JABIRU AIRCRAFT PTY LTD

SERVICE BULLETIN: JSB 027-1
Issue: 1
Date: 1st July 2009
Subject: Control Cable Clamp Inspection (Kit Models)

Figure 6 – Correct and Incorrect Clamp Installation

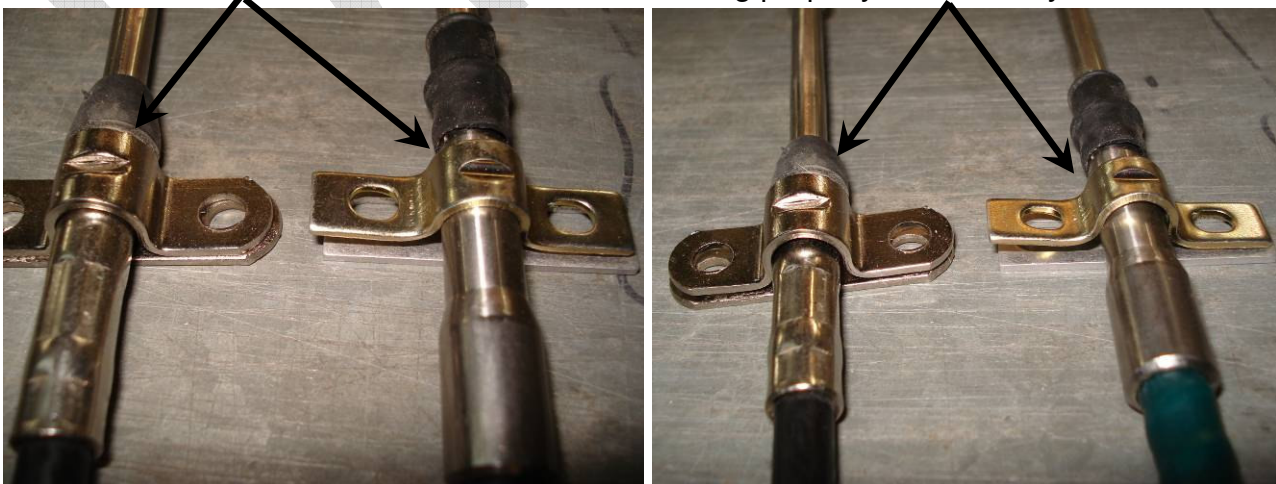
Clamps correctly assembled. Locking tangs correctly fitted, clamp fitting snugly around body of cable.

Clamps incorrectly assembled. Locking tangs misaligned, clamp not fitting properly around body of cable.

- Visually inspect each cable clamp fitted to the aircraft.
 - i. Ensure the correct type of clamp is fitted.
 - ii. Ensure the clamp is located correctly – i.e. directly over the locking slot in the cable end.

- iii. Ensure each clamp is correctly installed with the clamp tang engaging fully with the cable end fitting. Note that in some cases this may require the use of mirrors, torches etc to see enough angles of the clamp installation.
